# SOUTH CENTRAL WATERFRONT COMBINING DISTRICT & DENSITY BONUS PROGRAM (DRAFT – Staff Recommendations)

PLANNING DEPARTMENT  
CITY OF AUSTIN

DRAFT

Figure 3.2: SCW Subdistrict and Floor-to-Area Ratio Map

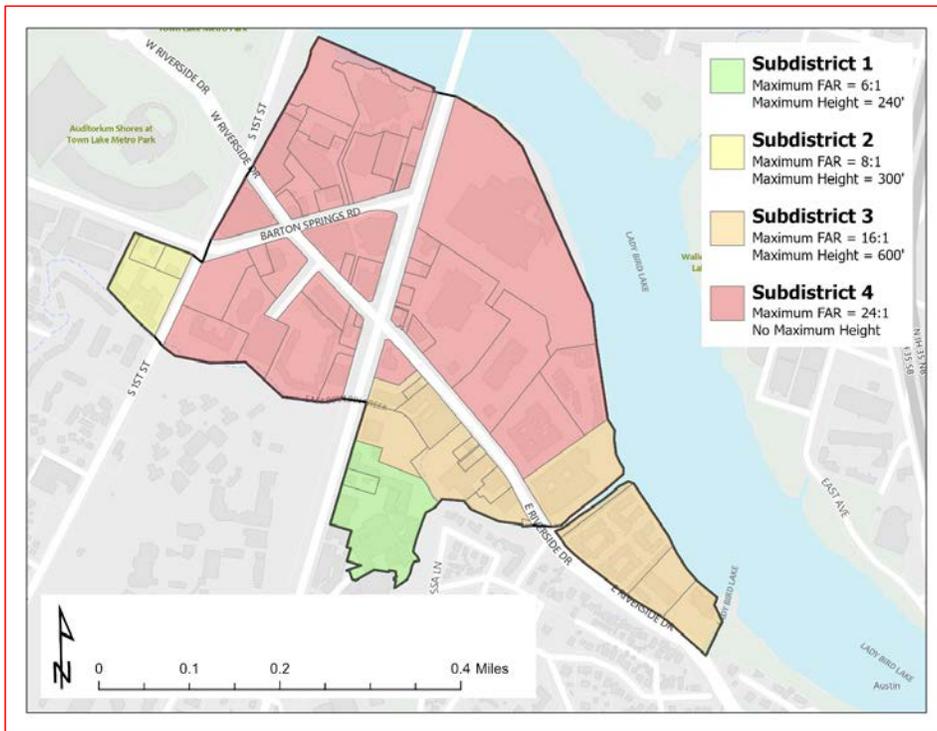
**Commented [MS1]:** Planning Commission Recommendation: Remove Subdistrict 1 and renumber:

Figure 4.2: Internal Circulation Route Option 2 Cross Section

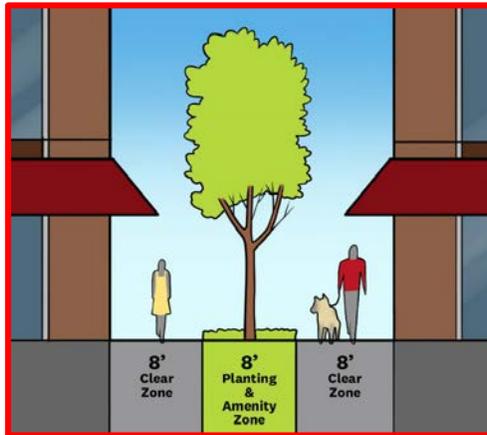
**Commented [MS3]:** Planning Commission Recommendation: REMOVE- "All internal circulation routes as described in [Section 3.5.1](#) (Density Distribution Areas) must have a minimum 15-foot width with either:"

**Commented [MS5]:** Planning Commission Recommendation: Increase from 10-foot to 15-foot.

**Commented [MS6]:** Planning Commission Recommendation: Expand the clear zone from 5 to 7.5 feet on each side. This recommendation was increased to 8 feet to comply with the Americans with Disabilities Act.

**Commented [MS7]:** Staff recommendation for shade trees.

Figure 4.3: Internal Circulation Route Option 3 Cross Section

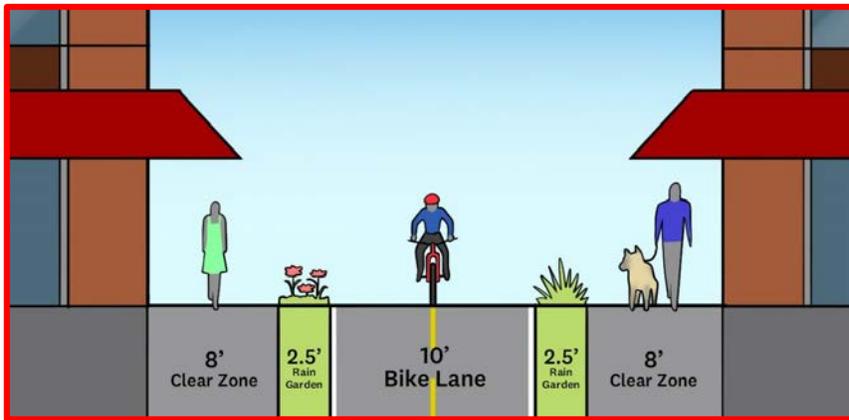
**Commented [MS8]:** Planning Commission Recommendation: Expand the clear zone from 5 to 7.5 feet on each side. This recommendation was increased to 8 feet to comply with the Americans with Disabilities Act.

**Commented [MS9]:** Staff recommends change to rain garden(s) from planting zone(s).

Figure 4.4: Internal Circulation Route Option 4 Cross Section

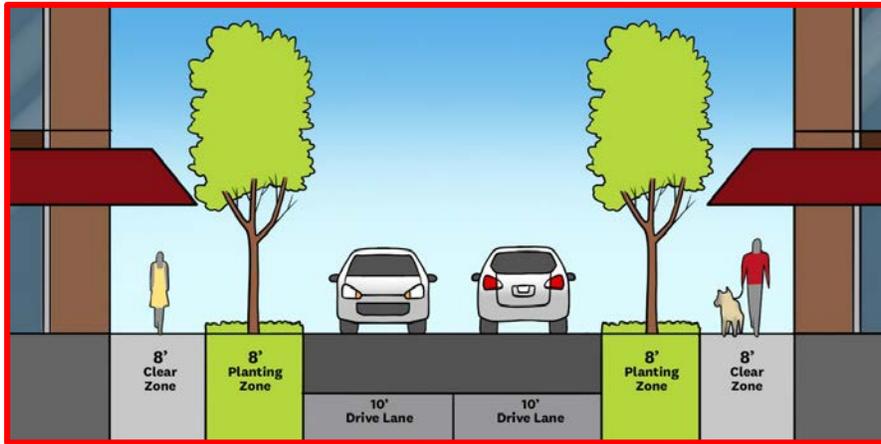
**Commented [MS10]:** Staff recommendation for shade trees.
